## **AMELIA LAKE SUBDIVISION,** **PHASES 1-2**

APPLICATION NUMBER 1 DATE September 18, 2014

APPLICANT Amelia Lake Subdivision, Phase 1

REQUEST Subdivision

# DETAIL SITE PLAN

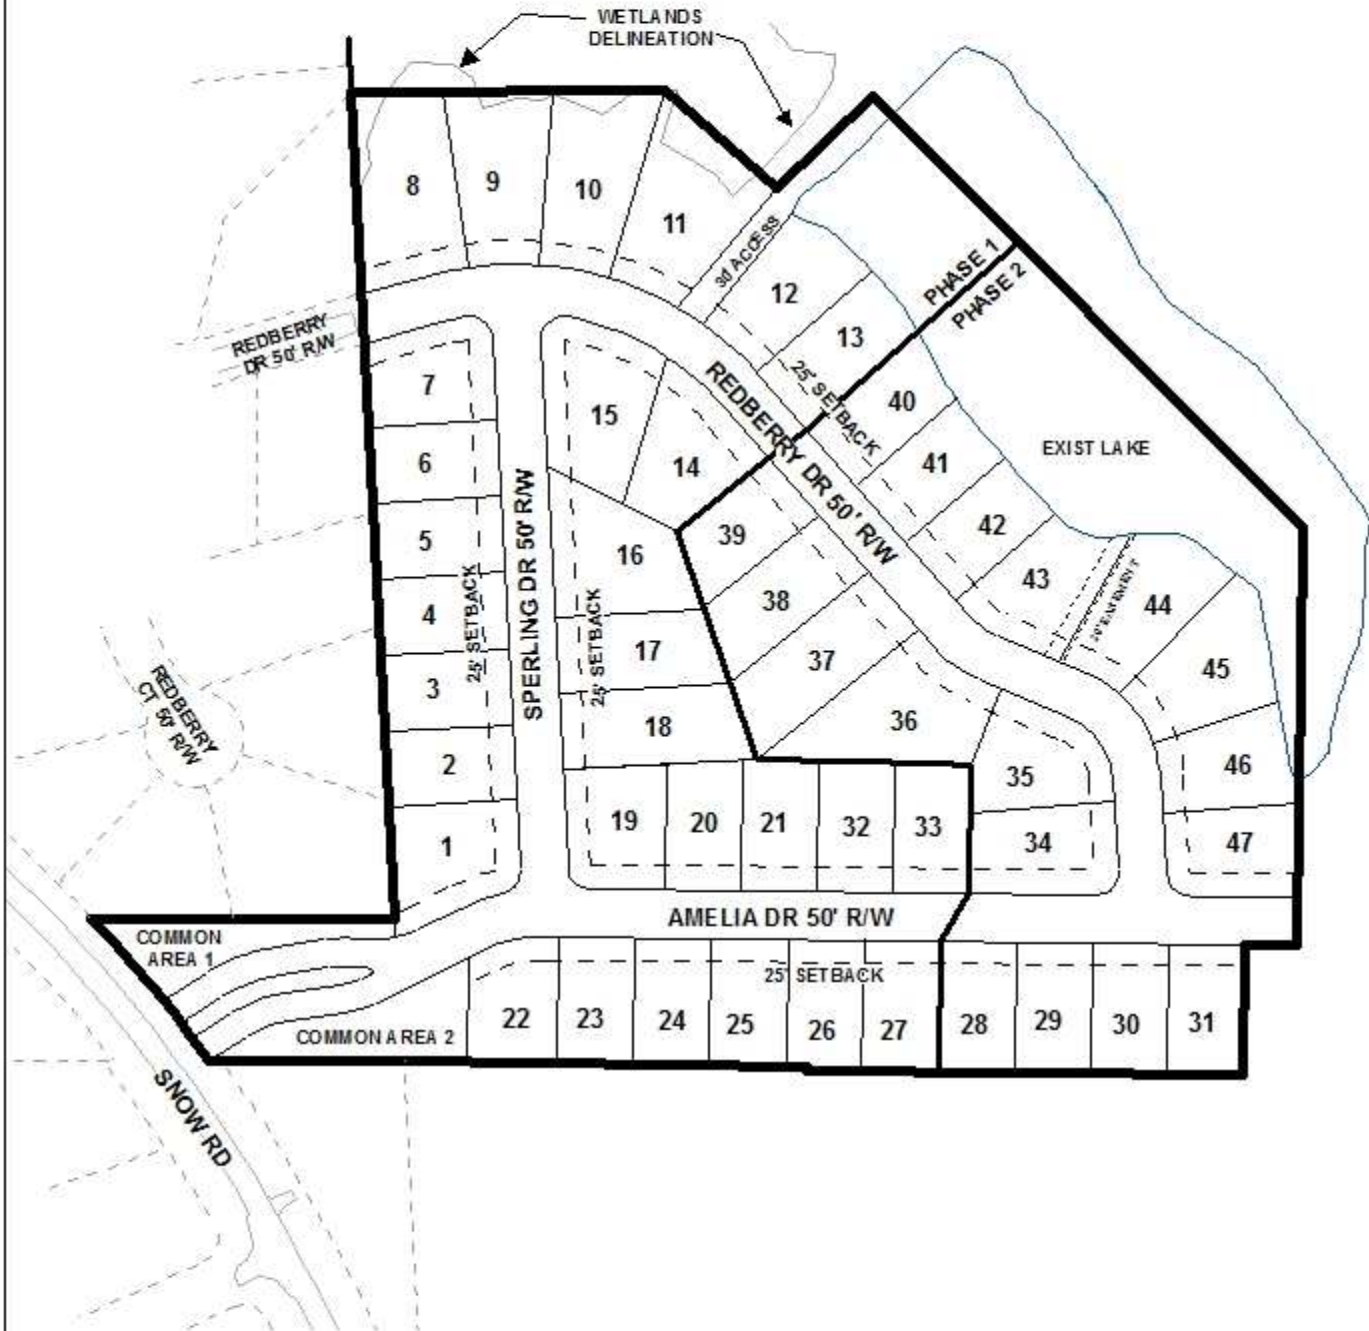
*The proposed subdivision fronts Snow Road, a future major street as defined by the Major Street Plan component of the Comprehensive Plan. As a minimum right-of-way of 100' is required, dedication, to Mobile County, sufficient to provide 50' as measured from centerline, should be required. If approved, the 25' minimum building setback line and lot size information should be revised to reflect dedication.*

*It should be pointed out that the proposed Lot 48 appears to contain an existing driveway which serves as egress/ingress for the existing dwelling unit. The existing driveway is depicted as Amelia Drive within the proposed Phases 1 and 2; however, there does not appear to be any plans to improve the existing drive within Lot 48 at this time. As such, no future subdivision of the proposed lot should be allowed until the existing driveway is paved and improved to Mobile County Engineering standards, if approved.*

*As a means of access management, a note should be placed on the Final Plat limiting the site to 1 curb-cut to Snow Road and all proposed lots to one curb-cut, with the size, design and location to be approved by Mobile County Engineering and conform to AASHTO standards.*

*The preliminary plat illustrates several common areas. The largest is labeled as an existing lake with the majority situated in Phase 1 and a portion of Phase 2, with access via a 30' access and common area through Phase 1. If approved, the Final Plat should include a note stating that all common and detention areas shall be maintained by the property owners.*

*The plat also depicts the presence of a 20' drainage easement and, if approved, a note should be placed on the Final Plat stating that no permanent structures can be placed or erected within any easement.*

- 6) Placement of a note on the Final Plat stating the provision of a temporary turnaround in compliance with Section V.D.6. of the Subdivision Regulations is required at the terminus of Redberry and Amelia Drives at the time of development of each phase;*

- 1) Revision of the Final Plat to depict dedication along Snow Road, to Mobile County, sufficient to provide 50' as measured from centerline;*
- 2) Revision of the lot size information and 25' minimum building setback line on the Final Plat to reflect dedication;*

- 3) Placement of a note on the Final Plat stating no future subdivision of Lot 48 until the existing driveway is paved and improved as a street to Mobile County Engineering Standards;*

- 4) Placement of a note on the Final Plat stating that all common and detention areas shall be maintained by the property owners;*
- 5) Placement of a note on the Final Plat stating that all proposed streets must be built to Mobile County Engineering standards and be accepted by Mobile County prior to the signing of the Final Plat;*

- 7) Placement of a note on the Final Plat stating that the site is limited to one curb-cut to Snow Road and all proposed lots are limited to one curb-cut each, with the size, design and location to be approved by Mobile County Engineering and conform to AASHTO standards;*

- 8) Placement of a note on the Final Plat stating that no permanent structures can be placed in any easement;*
- 9) Placement of a note on the Final Plat stating: (The approval of all applicable federal, state and local environmental agencies regarding flood zones and wetlands, would be required prior to the issuance of any permits or land disturbance activities.);*
